EXTARDER PRODUCT ADVISORY 94-1

SUBJECT: PRESSURE RELIEF VALVE P/N 19485

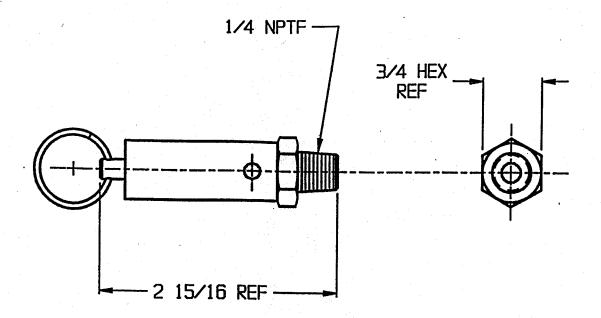
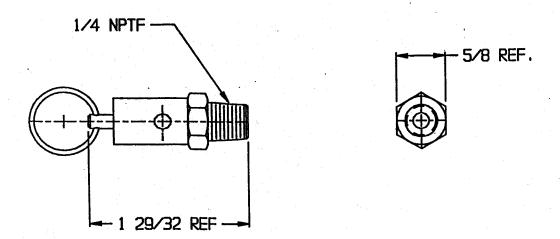
Extarder Product Advisory 93-2, issued November 15, 1993 advised of a potential problem that had been discovered with several installations of the Pneumatic Group (P/N 19482), related to an inability to maintain Reservoir air pressure. This problem had been tracked down to a leaky Pressure Relief Valve, P/N 19485.

Jacobs has now revised this component to correct the problem.

Please remove the old pressure relief valves from the kits and groups in your inventory and replace with the new valve. The revised valve is physically smaller than the original valve, and may be identified from the attached sketch.

Return all the old pressure relief valves to Jacobs.
